Service Information

File In/With: –		SI0557	
		New	823
Equipment Affected:	All Chillers with a OptiView Control Panel and Replacement Parts		
DC Power Supply 025-34111-000

This purpose of this service information letter is to provide notice of a new supplier of the DC power supply 025-34111-000 in the OptiView control panel.

LD32723

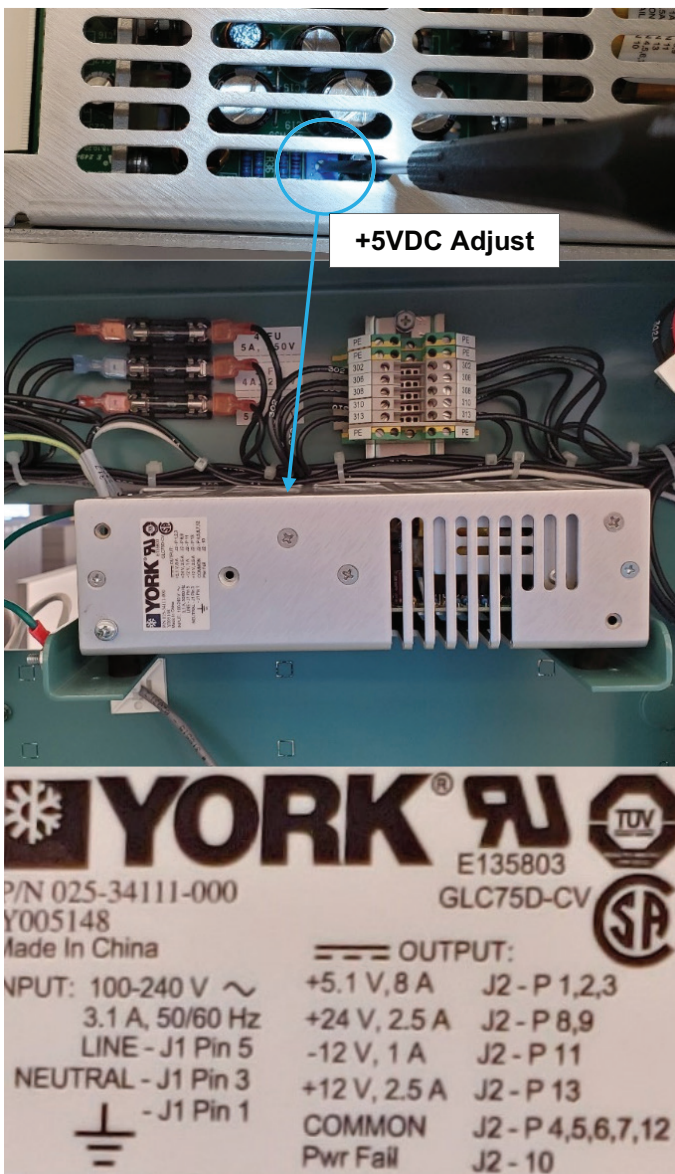
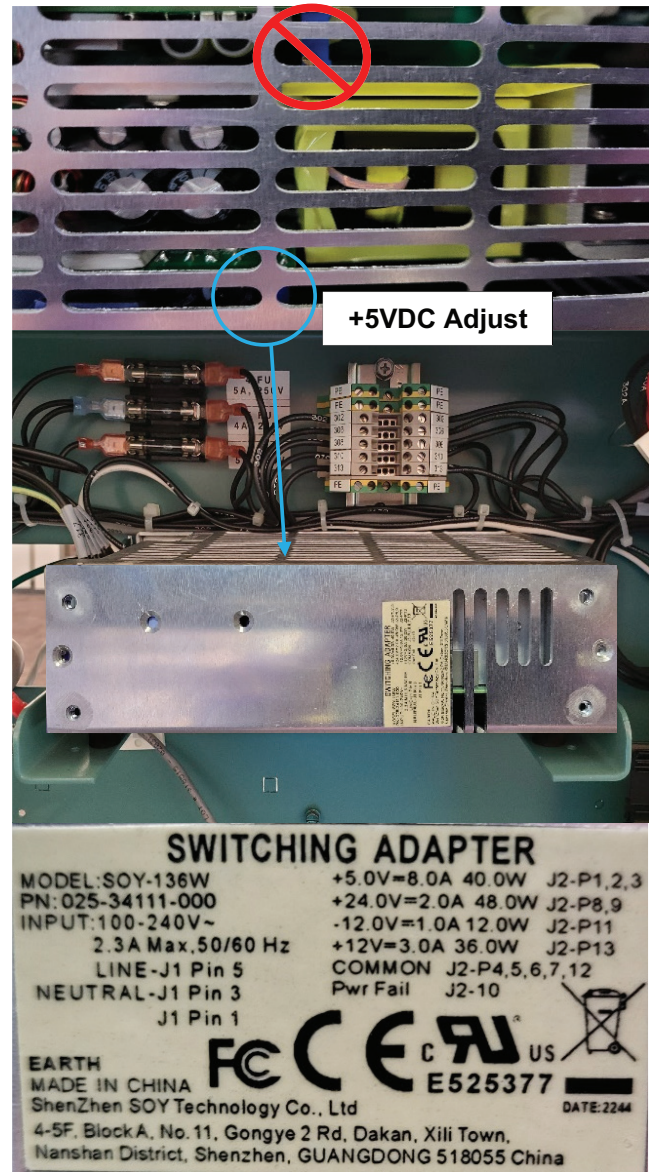
The form, fit, and function are the same. One notable difference is the +5 VDC adjustment potentiometer access. The +5 VDC supply is verified and adjusted as required at the manufacturer, so adjustment should not be necessary. However, if adjustment is required the cover on the new power supply must be removed to adjust the +5 VDC output. The figures below can be used to identify the new and previous suppliers.

LD32724

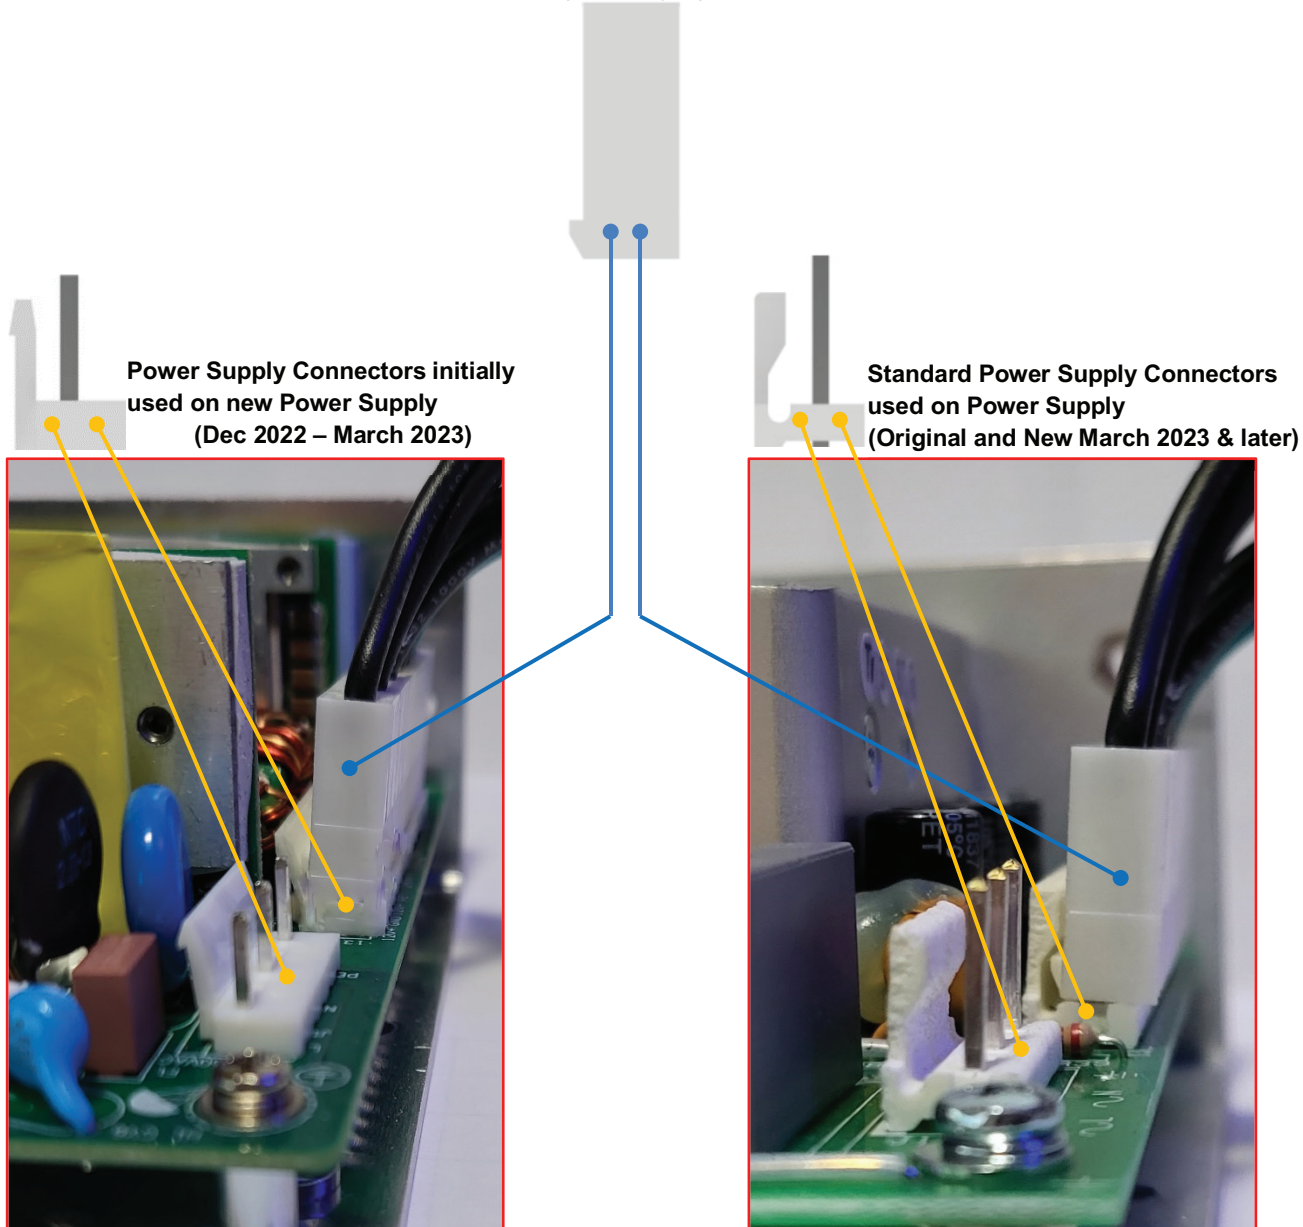
Additionally, you may notice the J1 and J2 connectors on the power supply are not the standard mating connectors. As previously mentioned, this was a temporary solution until the standard connectors became available. The wire harness connectors must be pushed on with more force, but they will mate with the power supply connectors. It will appear that the connection is not correct, but this has been vibration tested and approved by engineering, so no further action is required for these connectors.
